The Town of Hilton Head Island
Design Review Board Regular Meeting
Tuesday, December 10, 2019 – 1:15 p.m.
Benjamin M. Racusin Council Chambers
AGENDA

Town of Hilton Head Island
Design Review Board
Tuesday, November 26, 2019 at 1:15 p.m.
Benjamin M. Racusin Council Chambers

MEETING MINUTES

SHEET CONTENTS:
 BUILDING TYPE I
 ELEVATIONS
 SHEET NO.
A-4.16

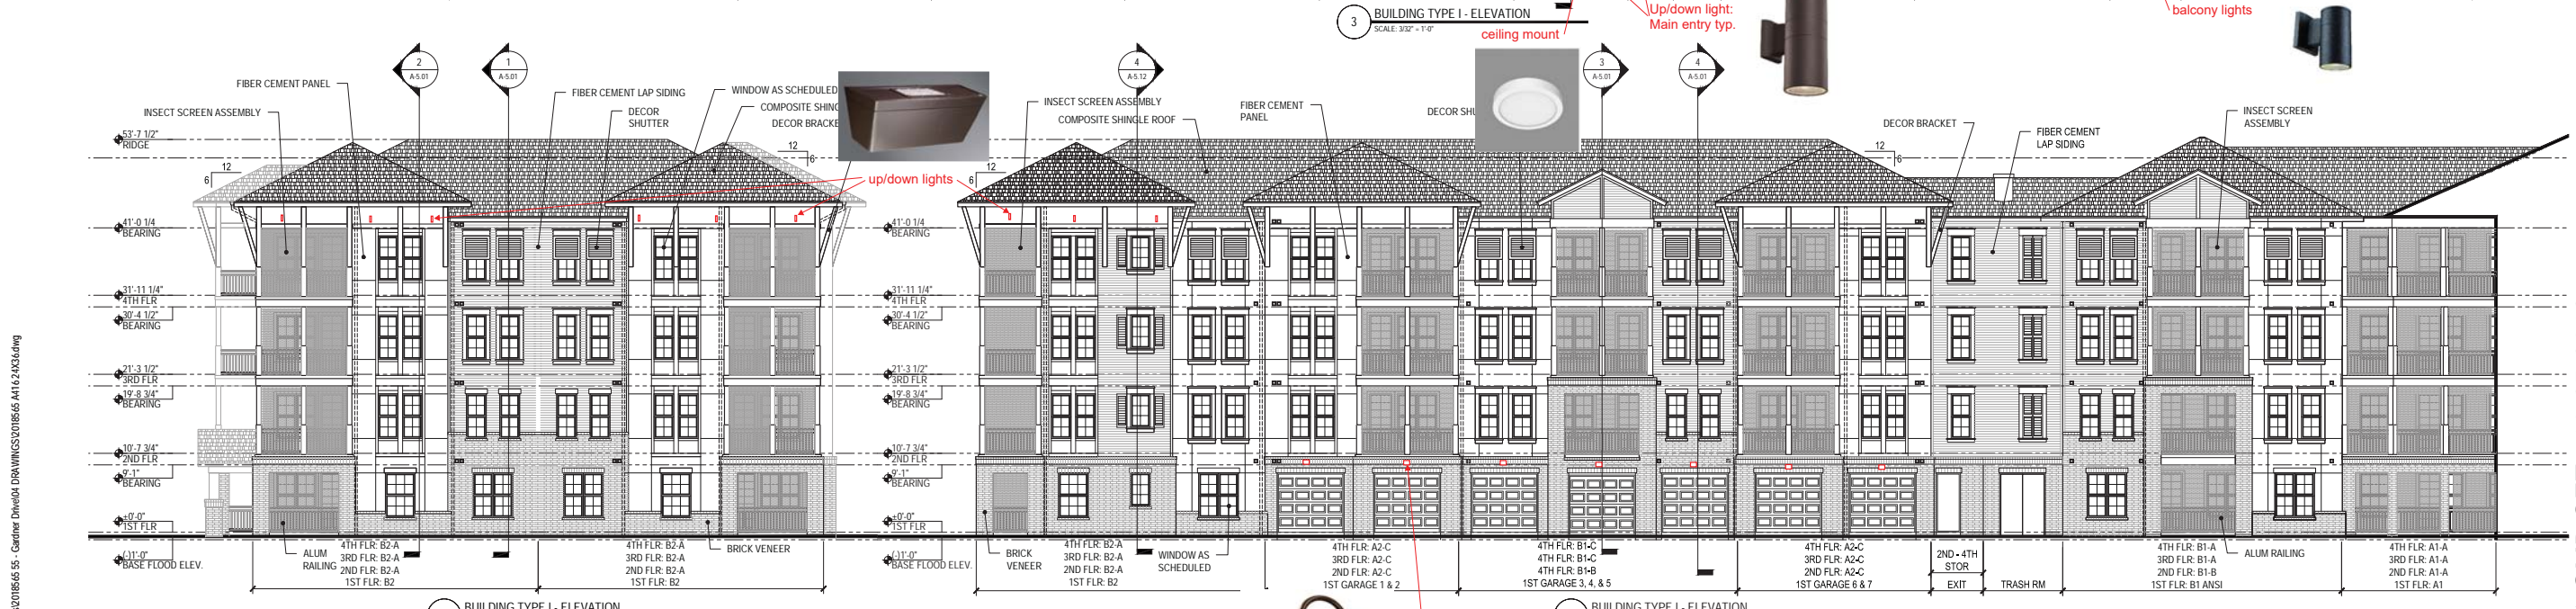
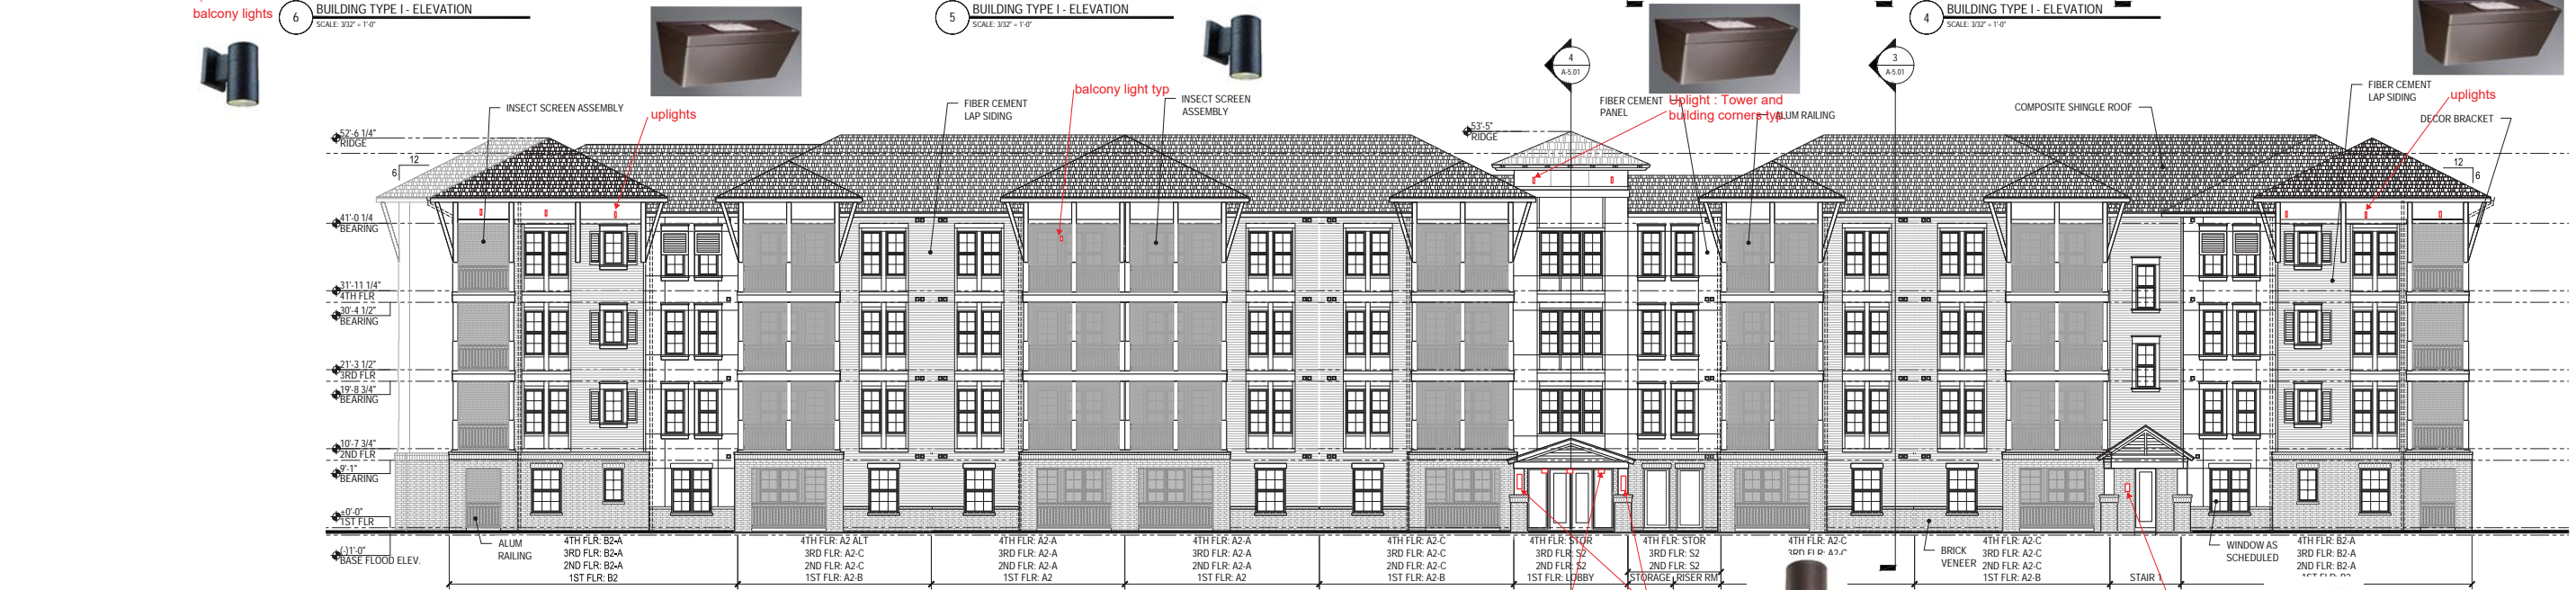
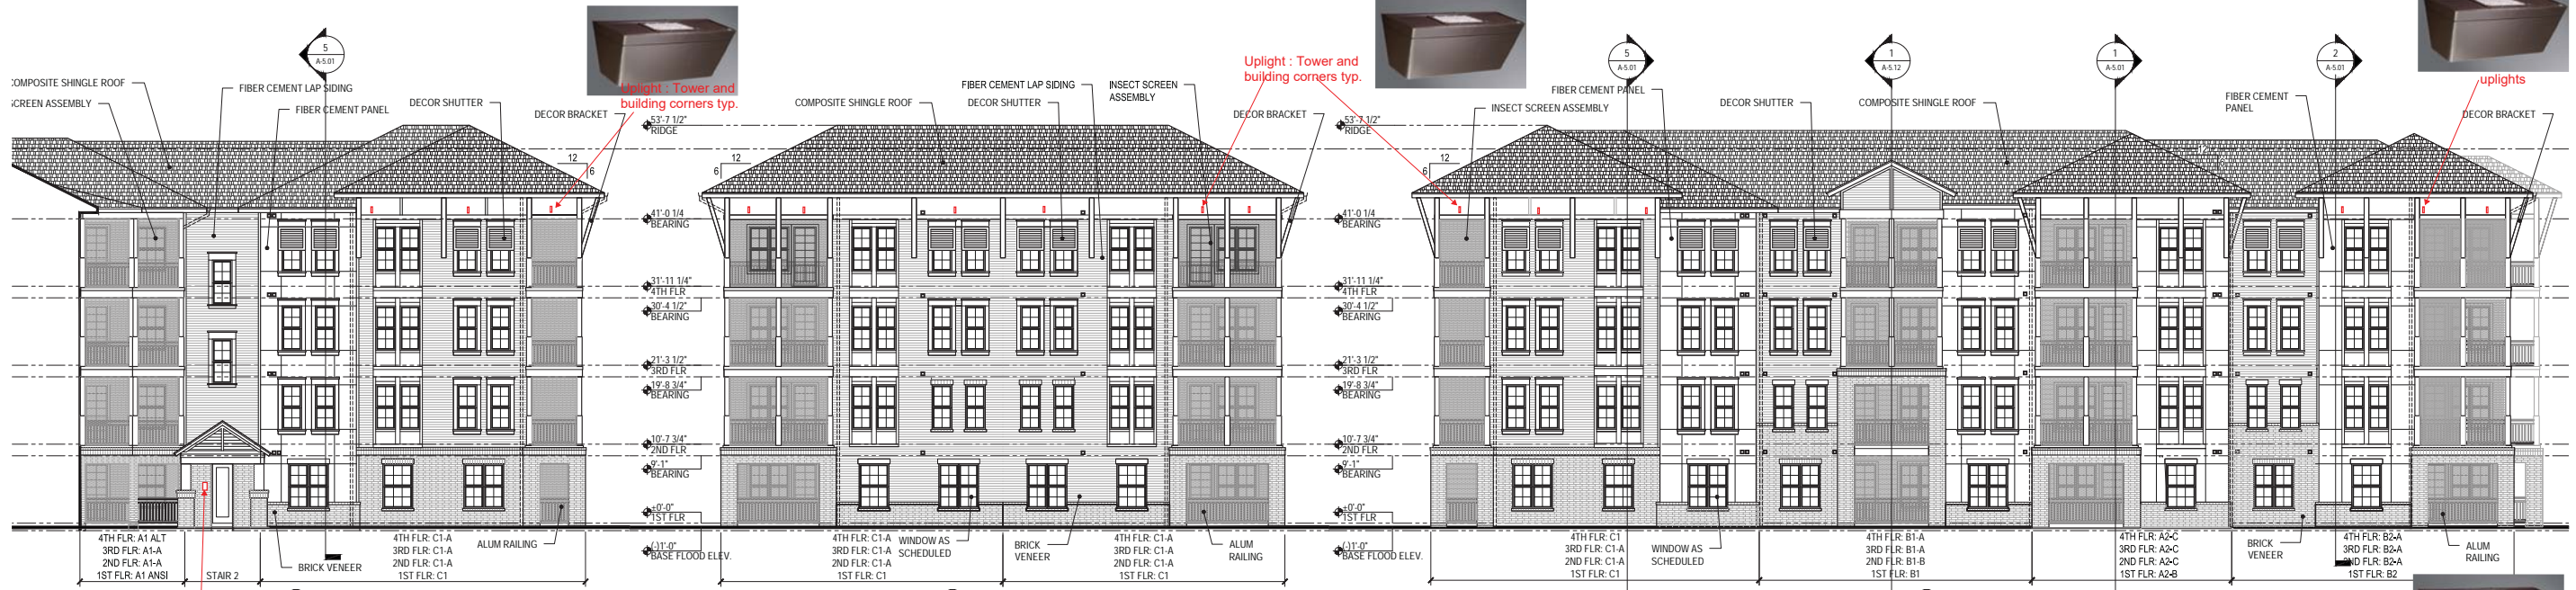
1. Revise site lighting for Town Staff review and approval as follows:
 - a. On the plans, revise the building “Uplight” and pickle ball court lights specification to 3000K or less.

- b. Shield the back parking lot lights on the southern property line as on the northern part of the site.
2. Revise the color specification of the truncated domes to brown.

3. Revise the color specification of the pickle ball court fence to brown.
4. Provide a tree preservation plan for Town Staff review and approval that:
 - a. Provides for pre-construction cambistat or equal treatment of key existing trees and treat pines for beetles (Gardner – 22 G, 14 WO, 15 WO, 28 P, 23 P; Southern – 24 LA, 21 WO, 19 WO, 26 P, 20 P, 26 P, 25 P, 24 P, 19 P).

- b. Reroute electrical lines or specify directional bore to accommodate the existing trees to be preserved along Gardner Drive.
 - c. Revise the planting plans for Town Staff to replace the proposed palms with pines along the southern property line.

G1 PROPOSED ELEVATION

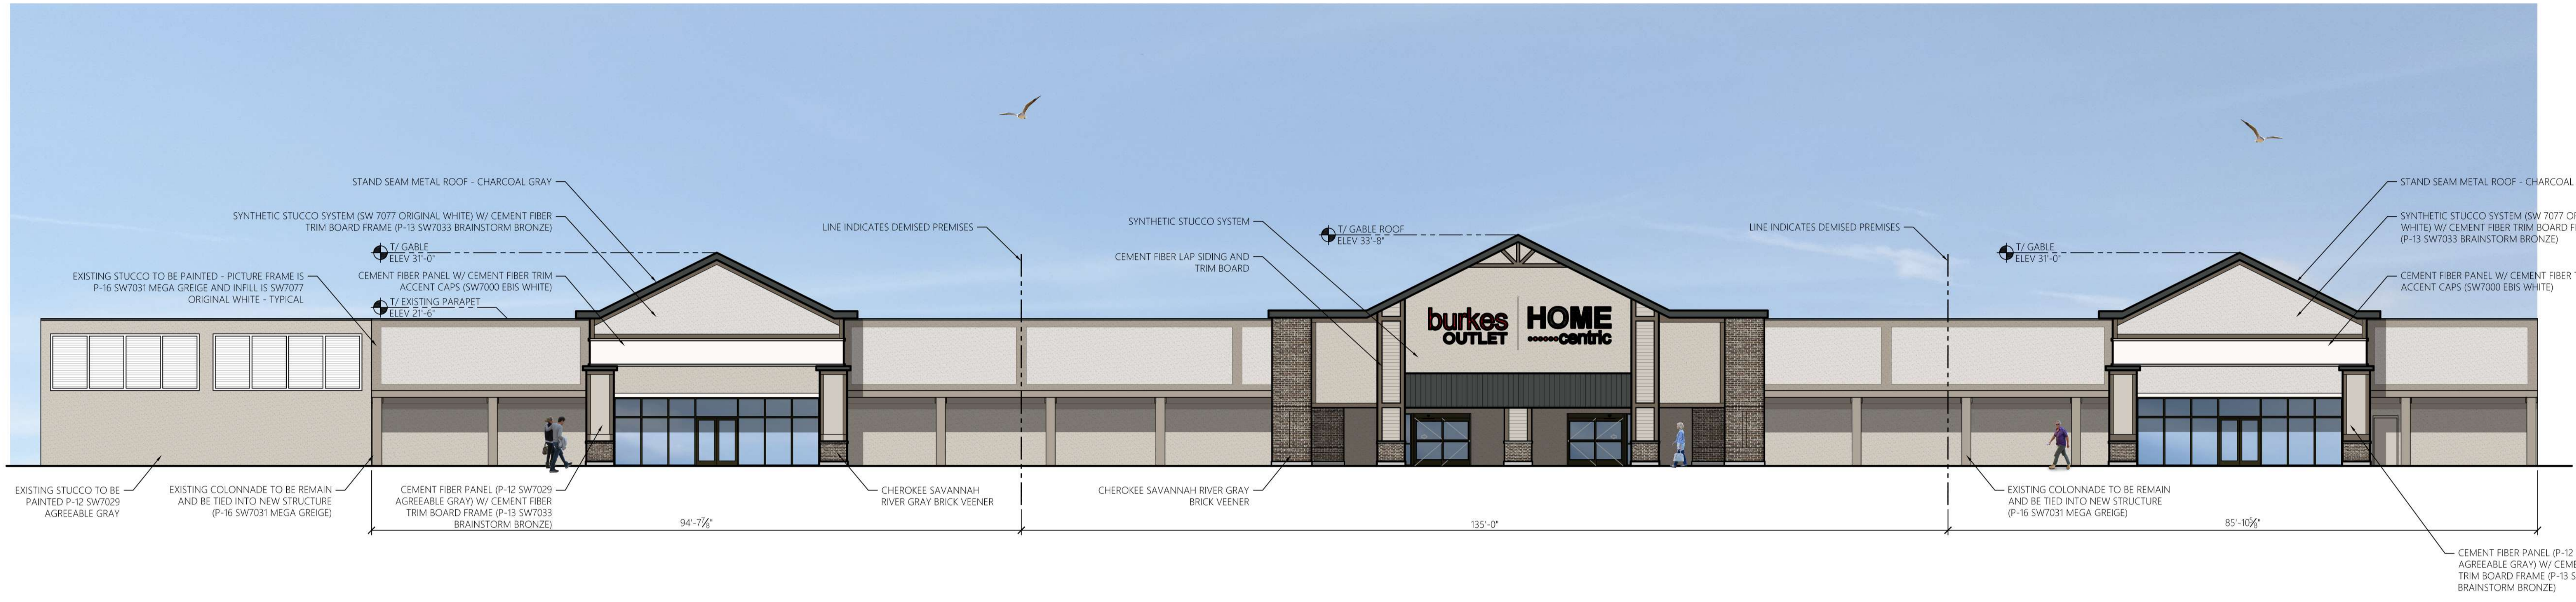
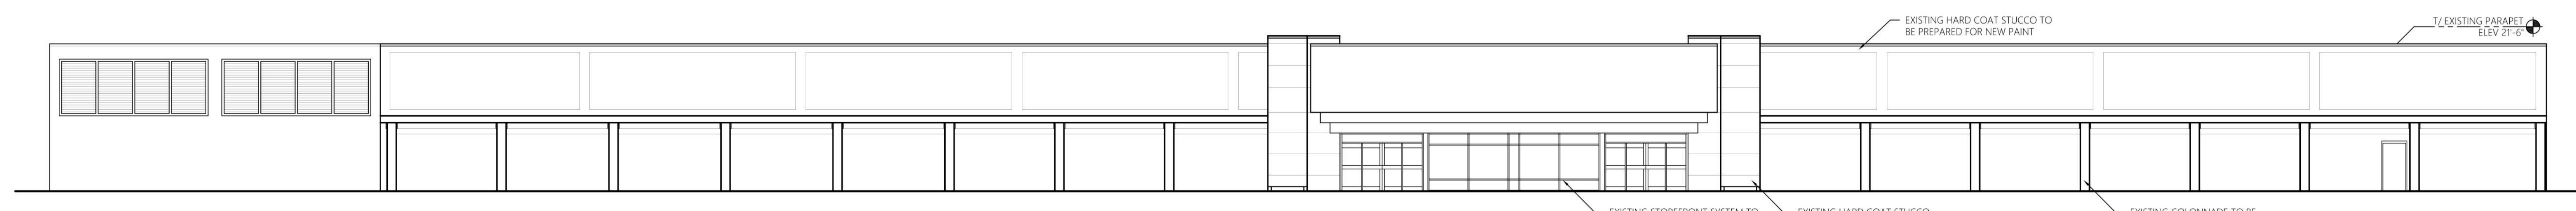
<i>APPLICATION MATERIAL</i>				
DRB REQUIREMENTS	Complies Yes	No	Not Applicable	Comments or Conditions
Dimensioned Details and of Sections	<input type="checkbox"/>	<input checked="" type="checkbox"/>	<input type="checkbox"/>	Provide dimensions on proposed and existing areas critical to proposed changes.
Detail Illustrating Connection to Existing Structure	<input type="checkbox"/>	<input checked="" type="checkbox"/>	<input type="checkbox"/>	Provide section details of how the addition attached to the existing structure.

<i>ARCHITECTURAL DESIGN</i>				
DESIGN GUIDE/LMO CRITERIA	Complies Yes	No	Not Applicable	Comments or Conditions
Promotes pedestrian scale and circulation	<input type="checkbox"/>	<input checked="" type="checkbox"/>	<input type="checkbox"/>	Provide a plan of the entrance showing the existing conditions (concrete sidewalk, asphalt, columns, bollards) and proposed changes to illustrate changes in the footprint. How do these changes relate to the vehicular circulation in the parking lot?
Minimum roof pitch of 6/12	<input type="checkbox"/>	<input checked="" type="checkbox"/>	<input type="checkbox"/>	Identify the pitch of the proposed roofs. Future adjacent façade modification will need to coordinate.

Forms an details are sufficient to reduce the mass of the structure	<input type="checkbox"/>	<input checked="" type="checkbox"/>	<input type="checkbox"/>	Add details to the proposed brick columns to break up their mass and give them a more pedestrian scale.
Human scale is achieved by the use of proper proportions and architectural elements	<input type="checkbox"/>	<input checked="" type="checkbox"/>	<input type="checkbox"/>	See above
Decorative lighting is limited and low wattage and adds to the visual character	<input type="checkbox"/>	<input checked="" type="checkbox"/>	<input type="checkbox"/>	Will the canopy over the doors have lighting? If so please provide cut sheet. Lights should be 3000K or less and meet the LMO footcandle requirements. It appears the proposed light fixtures above the entrance exceed 3000K.

MISC COMMENTS/QUESTIONS	
1.	The notes indicate the façade is only to be painted from “demising wall to demising wall”. These extents are unclear. Please clarify. If any of the existing façade to remain is to be painted, the entire existing façade should be painted. It is Staffs understanding that the applicant is not painting the existing stucco.

2.	Provide for renovation of two landscape islands in front of the new entrance. The landscape note is not sufficient to specify landscaping.
3.	Note to DRB, the applicant has indicated that this is only one of a total of three tenants that will be in the old Sam’s location.

4.	Please indicate on the color board or on a drawing where the specified colors go on the proposed façade.
5.	Are there any changes being made to the back elevation of the building as part of this renovation? If so please provide plans. It is Staff’s understanding there are no plans to change the back elevations.

1. Clarify the exterior light fixtures do not exceed 3000K or change the specification.
2. Provide a landscape plan for Staff approval for the landscape island to include overstory trees.

WATER ELEVATION
 SCALE: 1/4" = 1'-0"

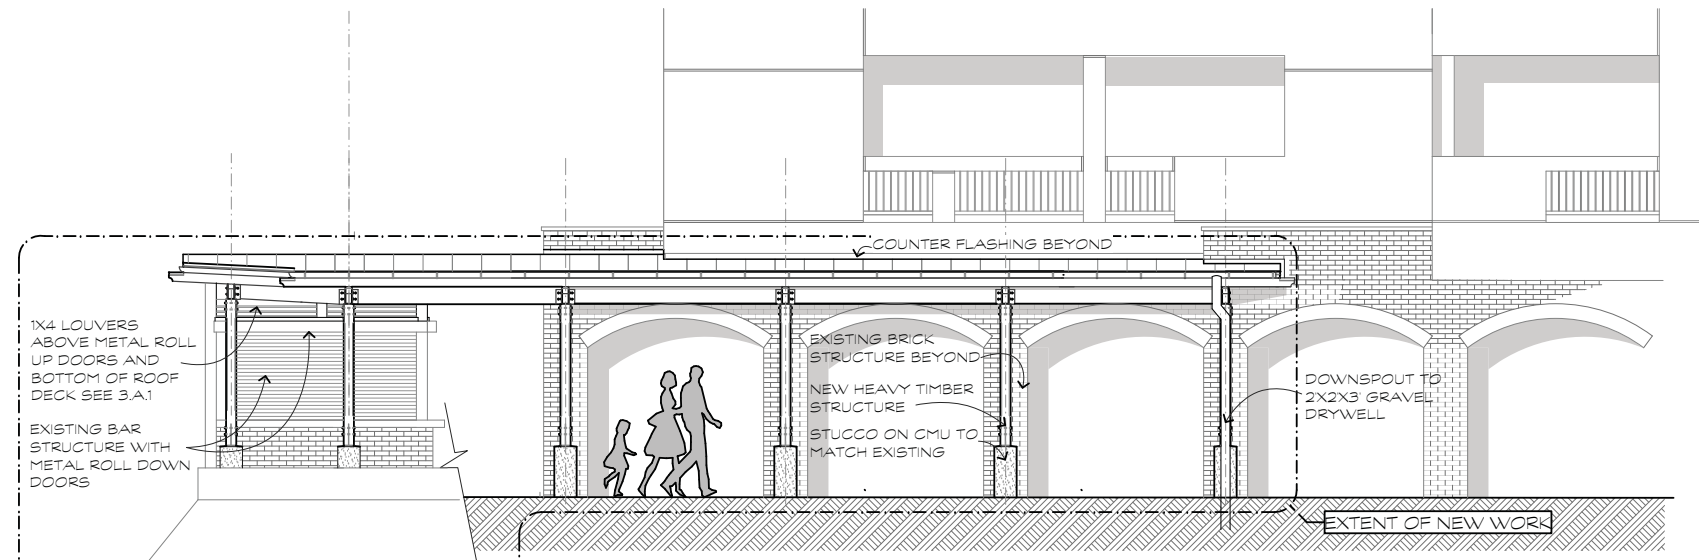
<i>APPLICATION MATERIAL</i>				
DRB REQUIREMENTS	Complies Yes	No	Not Applicable	Comments or Conditions
New Building Details Match Existing Building Details	<input type="checkbox"/>	<input checked="" type="checkbox"/>	<input type="checkbox"/>	The beams in the approved drawings and the proposed Loggia Section (sheet A.1) appear to be horizontal but are sloped in the proposed Left Side Elevation (sheet A.2)
